Project / Development Name (if applicable): Craycroft Development for Office Building

## PERMIT SUBMITTAL FOR DRB COMMENTS RESPONSE

### DEVELOPMENT PLAN SUBMITTAL COMMENTS 3<sup>rd</sup> RESPONSE

Subject: Craycroft Office Development, DP21-0086

1 DISABLED PARKING SIGN NO SCALE

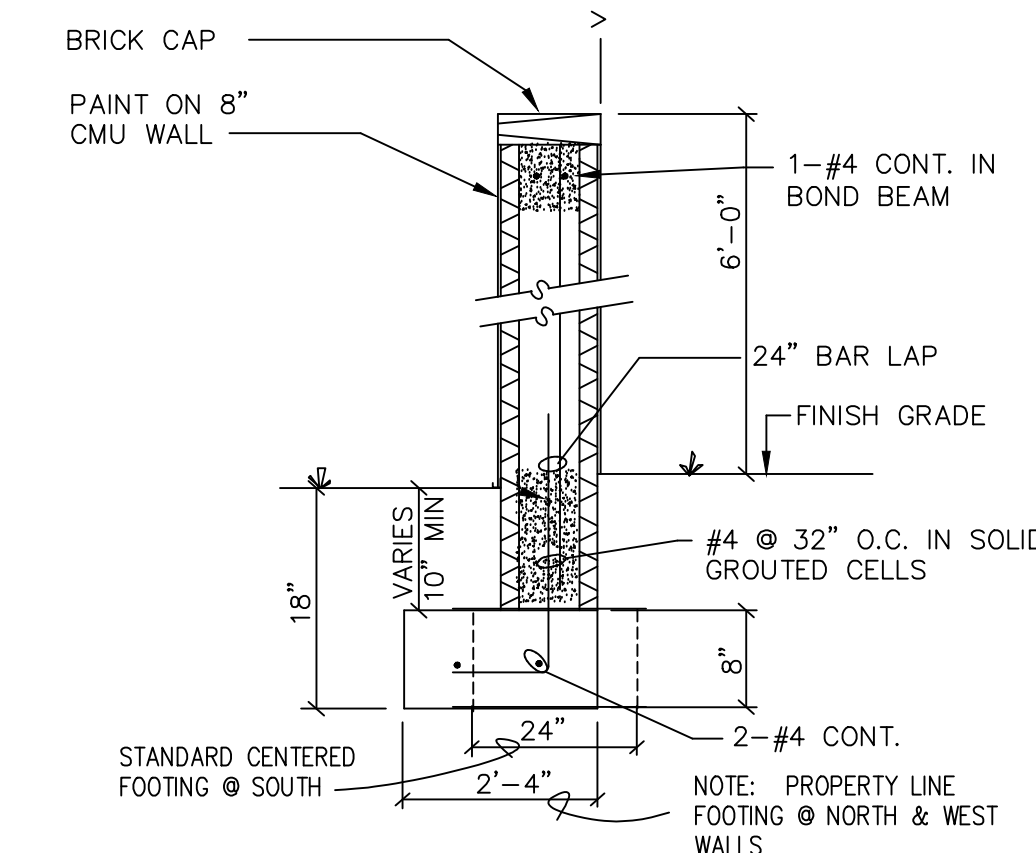
8. Previous comment 14 - This comment was not addressed correctly. The mounting height should be to the bottom of the van accessible sign. COMMENT: 2-06.4.9.H.5.a – Provide a mounting height dimension for the accessible sign on the detail. **RESPONSE: Detail revised and updated accordingly**

3 H/C ACCESSIBLE TYP NTS

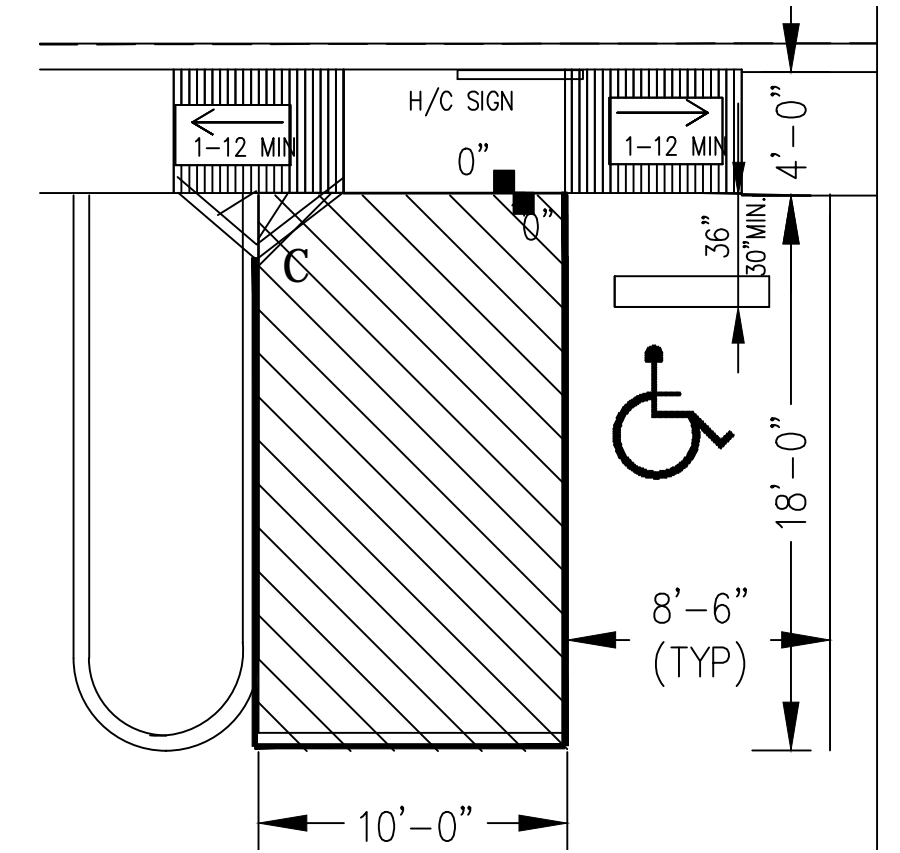
7. Previous comment 13 - This comment was not addressed correctly. Remove the reference to “36” on the “H/C ACCESSBLE TY” detail and the “3'-0”” on the “STANDARD PARKING SPACE” as this does not meet the requirements shown in UDC Article 7.4.6.H.3 . COMMENT: 2-06.4.9.H.5.a – Detail 3 sheet 2 the location dimension show for the wheel stop is not correct. Review UDC Article 7.4.6.H.3 and revise the detail. **RESPONSE: Detail revised and updated accordingly**

PROJECT: CRAYCROFT OFFICE  
DRAWING TITLE: SITE PLAN (PDP)

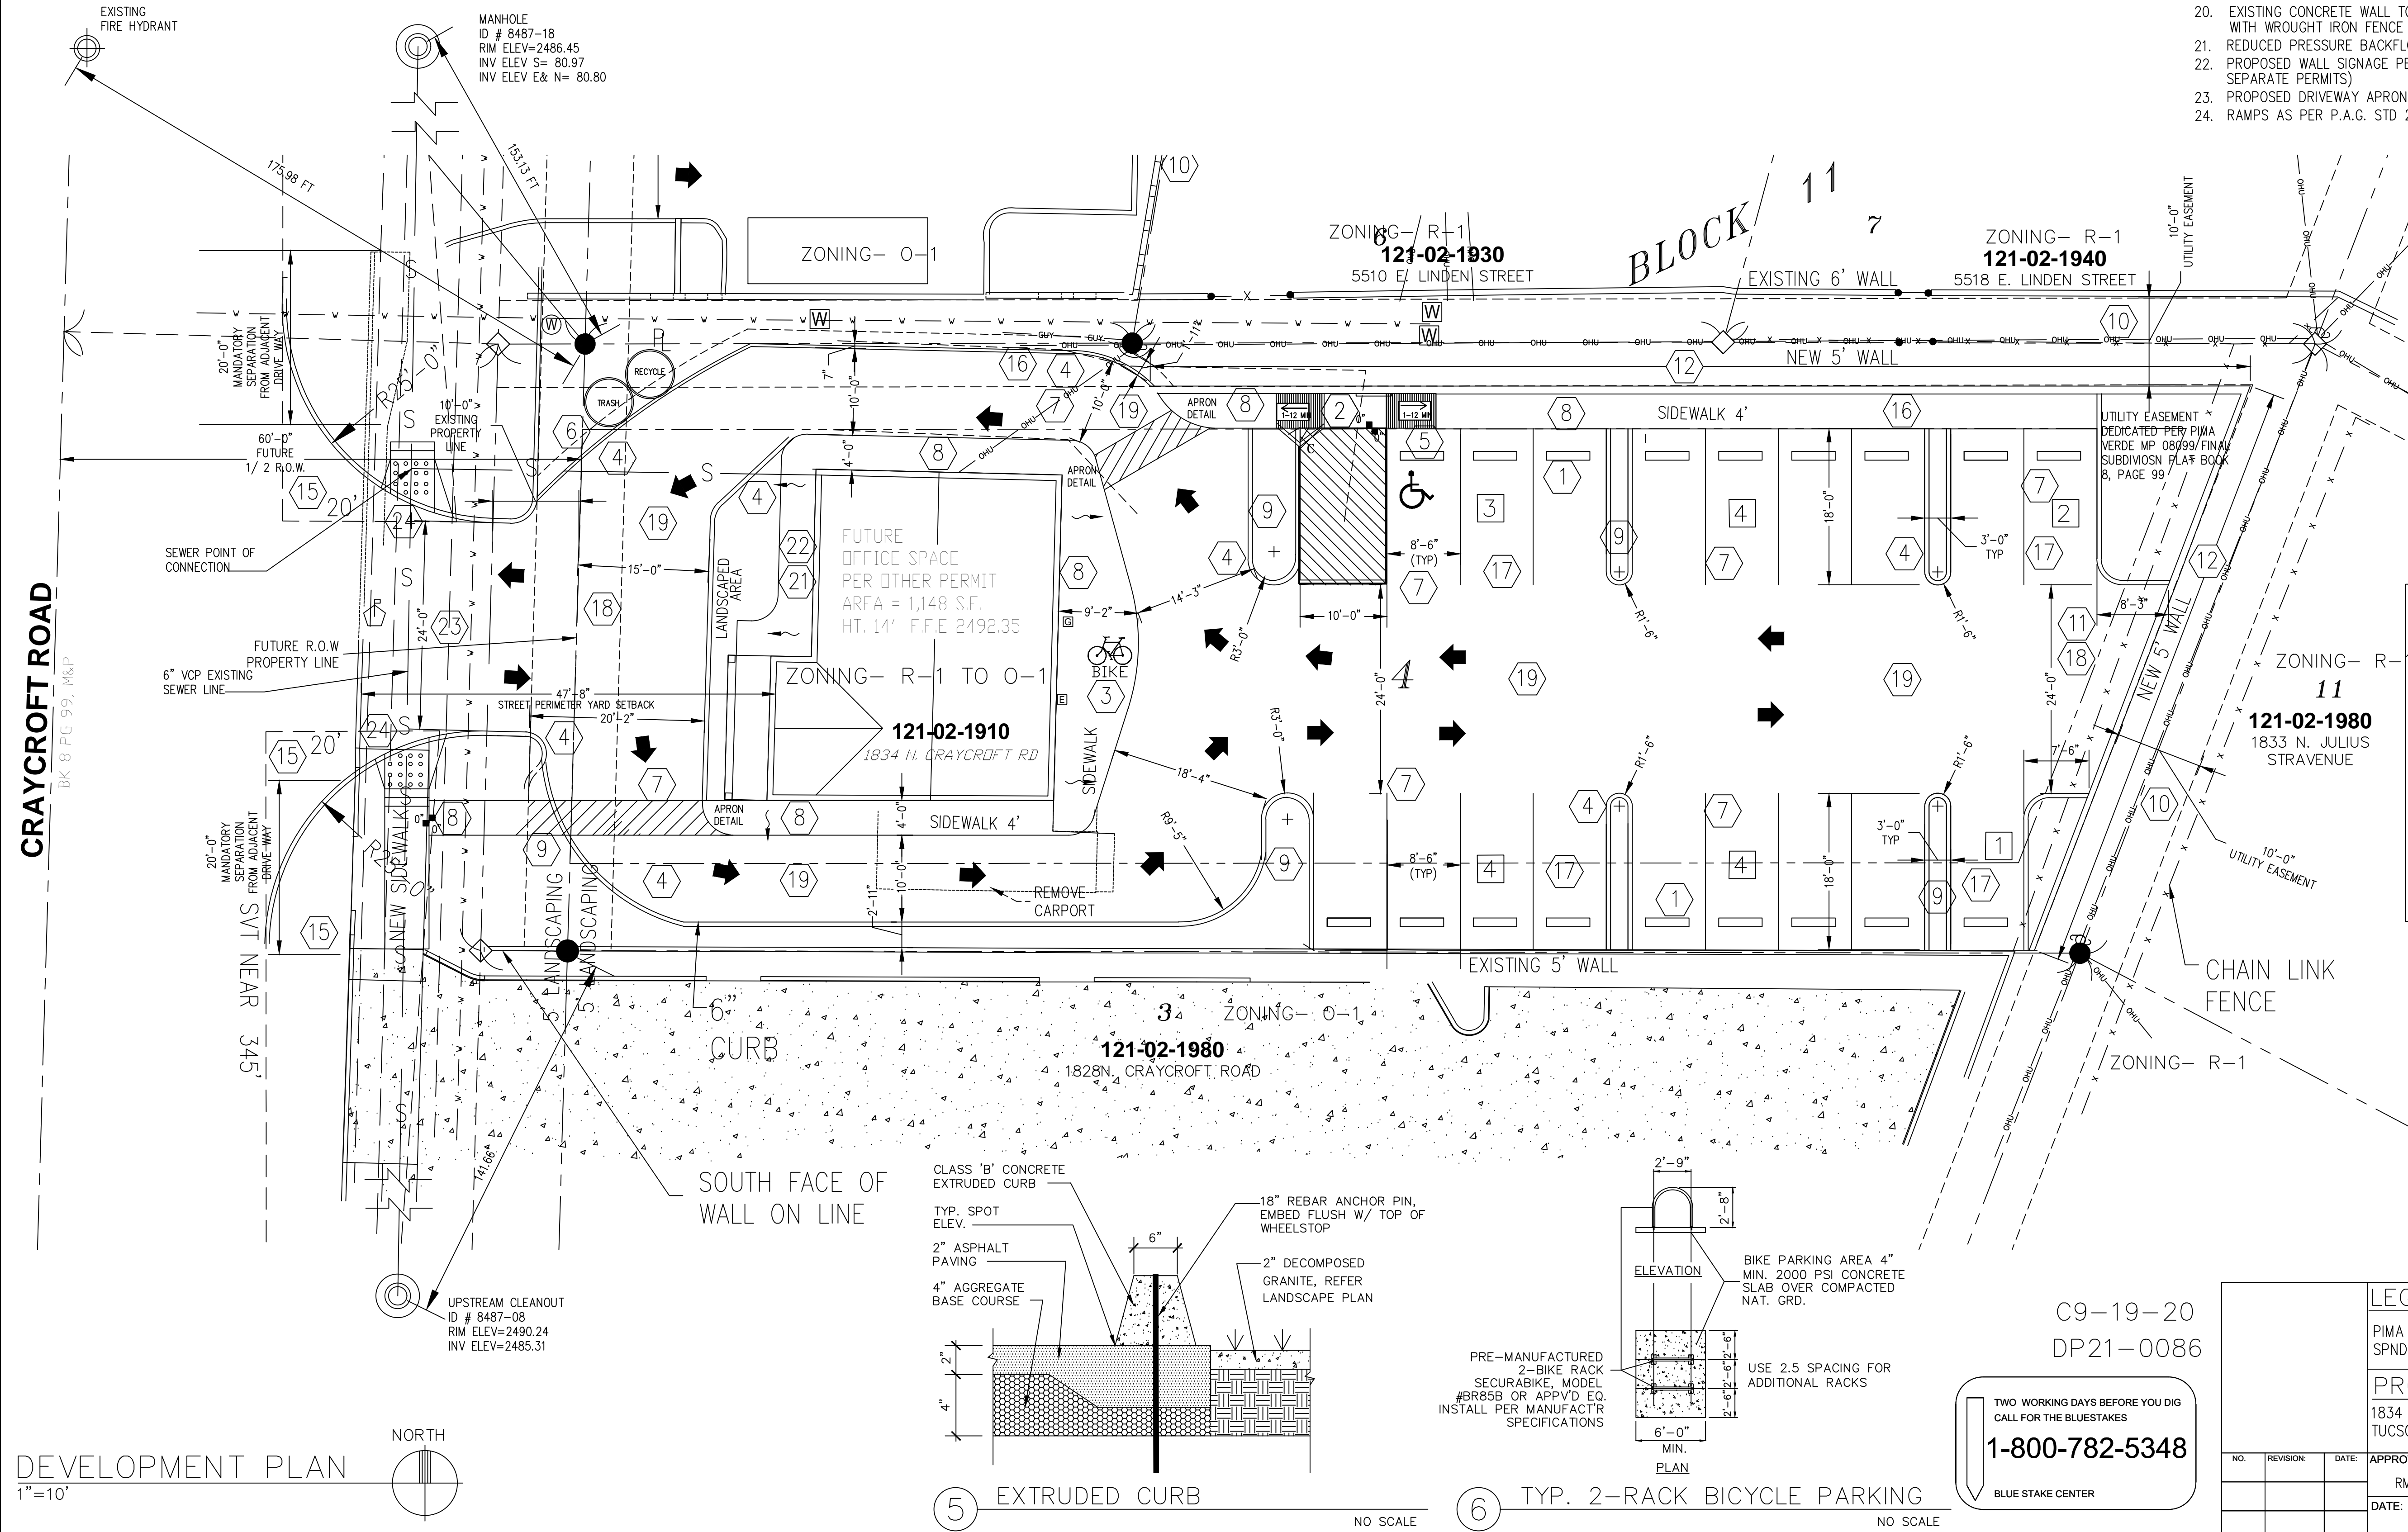
5. Previous comment 8 - Zoning was not able to find the future SVT's on the plan.COMMENT: 2-06.4.9.H.2 - Show future sight visibility triangles on the plan . On a designated MS&R street, the sight visibility triangles are based on the MS&R cross-section. **RESPONSE: SVT are indicated on plan based on the Future MS7R conditions**

6. Previous comment 10 - This comment was not fully addressed. Provide the radius for the back-up spur, see UDC Article 7.4.6.F.4. COMMENT: 2-06.4.9.H.5 – Dimension the back-up spur shown at the east end of the vehicle use area. **RESPONSE: Radius of back spur provided**

10. Previous comment 17 - This comment was not addressed. COMMENT: 2-06.4.9.J – Show the future curb for Craycroft on the plan. **RESPONSE: Future Curb indicated on Plan**

11. Previous comment 18 - This comment was not addressed. COMMENT: 2-06.4.9.O – Per UDC Article 11.4.6 definition of Established Area Setback and this site borders on a street designated as a major street on the COT MS&R Plan this site does not qualify for Established Area Setbacks. Therefore, the street perimeter yard setbacks for Craycroft Rd are based on UDC Article 6.4.5.C.2 and Table 6.4.5.C-1. ADT or 1,000 or greater. Provide a street perimeter yard setback form the existing building to the back of future curb. **RESPONSE: Setbacks provided**

12. Previous comment 19 - This comment was not addressed. COMMENT: 2-06.4.9.R – Clearly demonstrate that there is an accessible route from the accessible vehicle parking space to the accessible entrance of the building and from the accessible entrance to the sidewalk along Craycroft. Does not appear that there are any ramps provided. **RESPONSE: Accessible route indicated with arrows from parking area to building entrance**

1. Sheet C2- Due to the limited property frontage from Craycroft Rd. please update the entrance to P.A.G. Standard 206; Driveway Apron. (This is the modified 206 according to the "solid-circle note" on sheet 1 of 2- P.A.G. 206) **RESPONSE: Entrance Revised and Updated**

2. Sheet C2- Tie-in to existing sidewalk north of property entrance according to P.A.G. Standard 203 **RESPONSE: Standard PAG Detail 203 Added**
3. Sheet C2- Show spot grades of ADA compliance where sidewalk will meet new P.A.G. standard 206 driveway apron. **RESPONSE: Spot elevations added at ADA Ramps and Sidewalk**

4. Sheet C2, where Keynote 8 (4 Ft. wide raised concrete sidewalk) will intersect new sidewalk in the ROW, show spot grades that are in ADA compliance. **RESPONSE: Spot elevations added at ADA Ramps and Sidewalk**

5. Sheet C2- Due to Craycroft Rd. being an MS&R street, show "future" sight visibility triangle according to COT Development Standard, 3-01.5.1.B.2 **RESPONSE: Noted**

**LANDSCAPE PLAN**  
 1"=10'

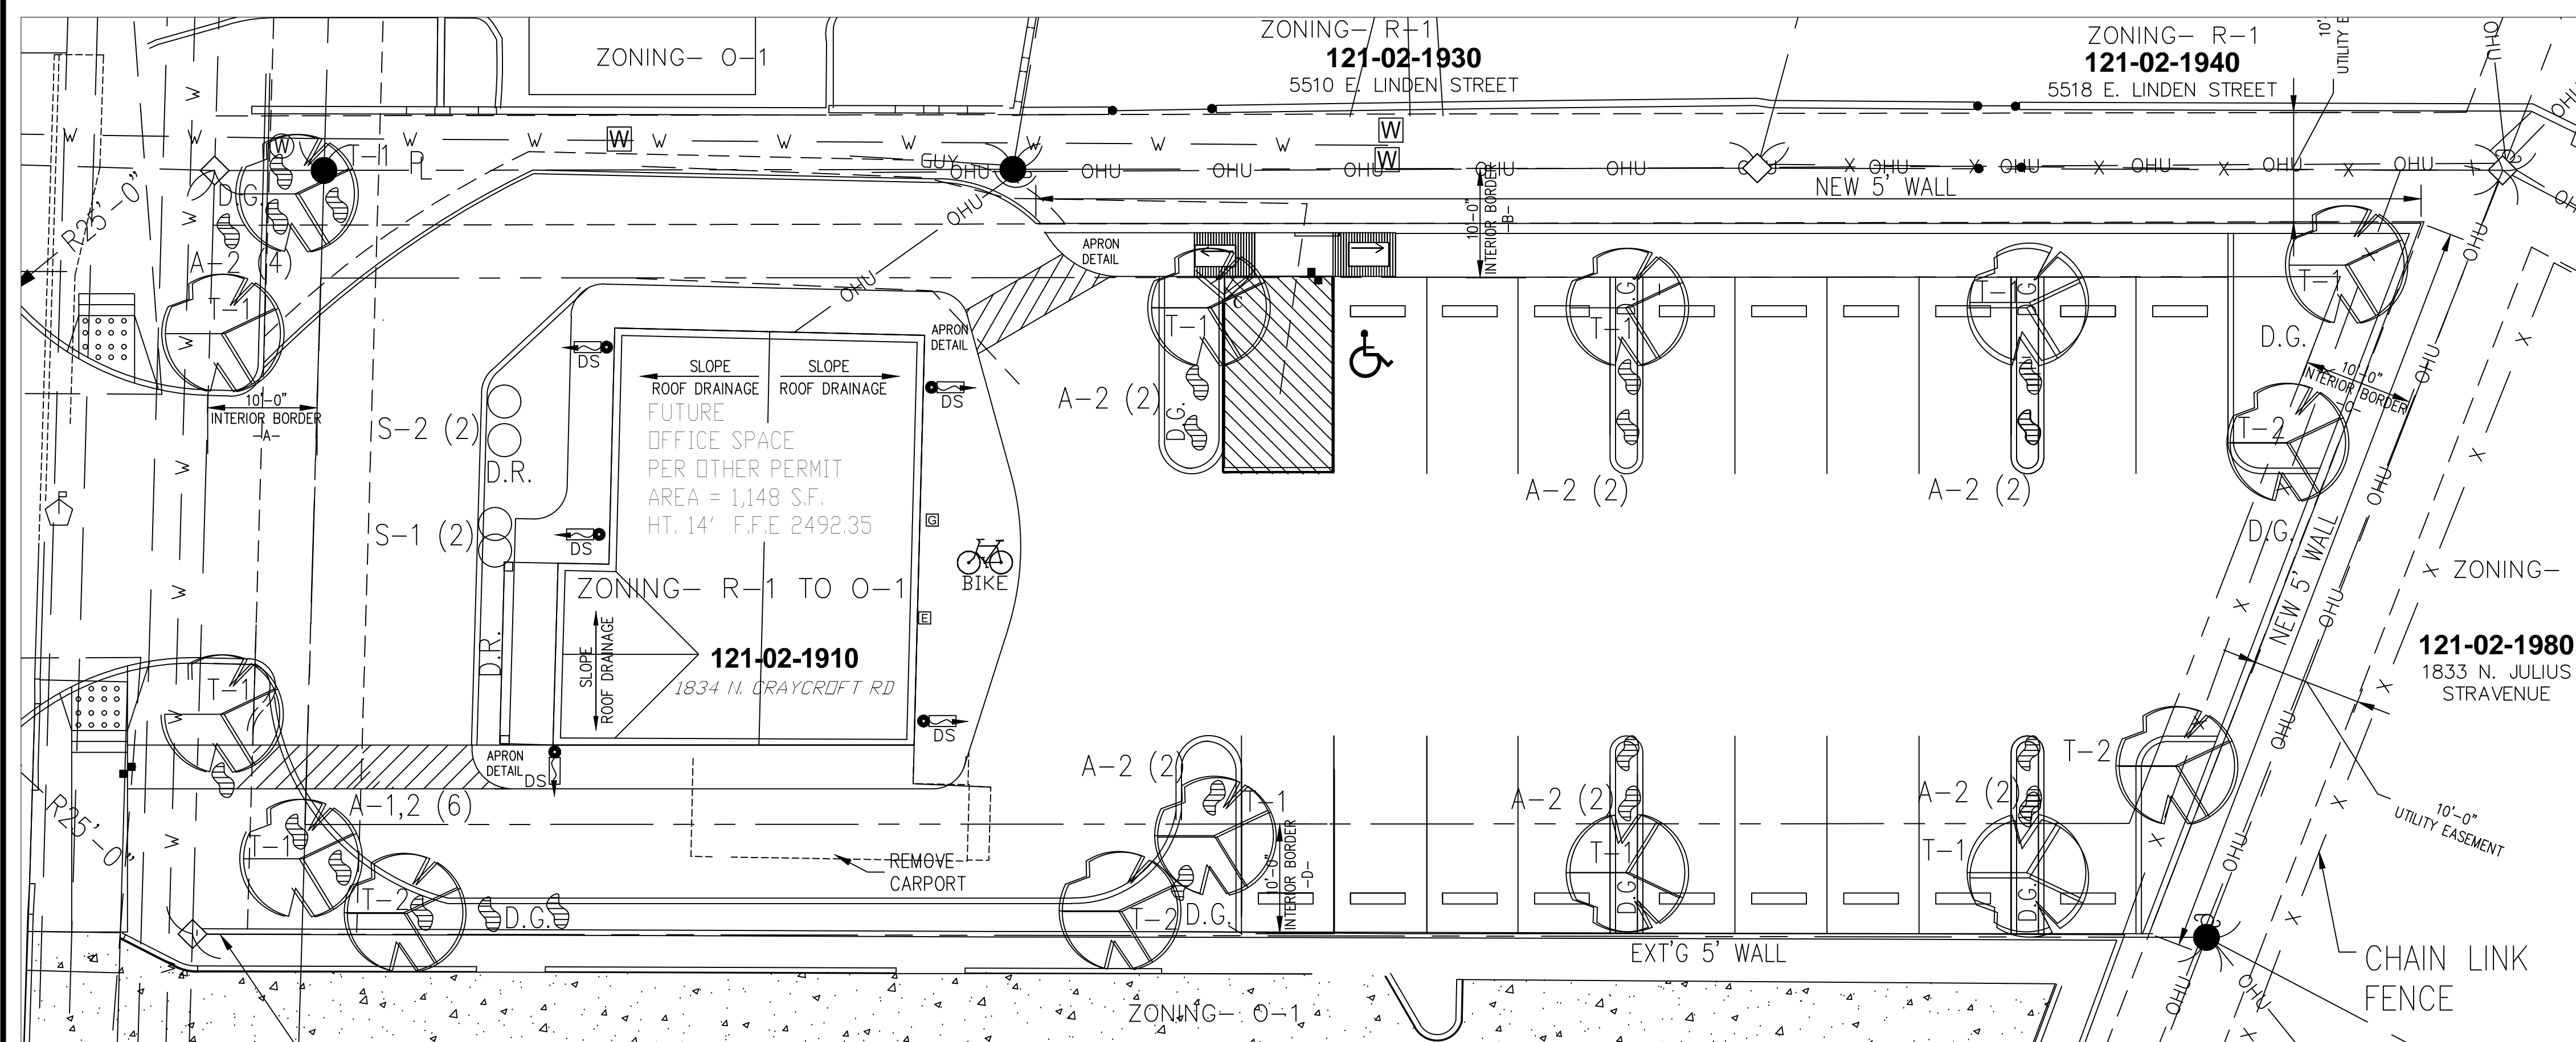
3. T-2 on the plant legend is missing the species, please revise. **RESPONSE: Species Added**

4. Notes #18 and #7 are incorrect and conflict with Note #19 , please revise. Note #28 and #29 are not relevant, please remove. **RESPONSE: Notes revised and removed per your request.**

5. Please provide, label and dimension north interior landscape border, AM Section 2-10-4.2.A.2.f. & .g. It is required adjacent to residential uses. **RESPONSE: Border Labeled**

6. An existing 6' wall occurs along the northern boundary, and a 5' wall is proposed. This creates an unsafe tunnel situation, demonstrate how the new wall complies with Safe by Design guidelines, Technical Standards Manual 5-01.6.0. A Design Development Option may be pursued to delete this requirement. **RESPONSE: A 6FT wall is proposed now.**

7. The street landscape border must provide 50% vegetative cover within the border, the plants indicated are insufficient, and calculations are incorrect. **RESPONSE: Acknowledged, calculations revised and updated per current codes**
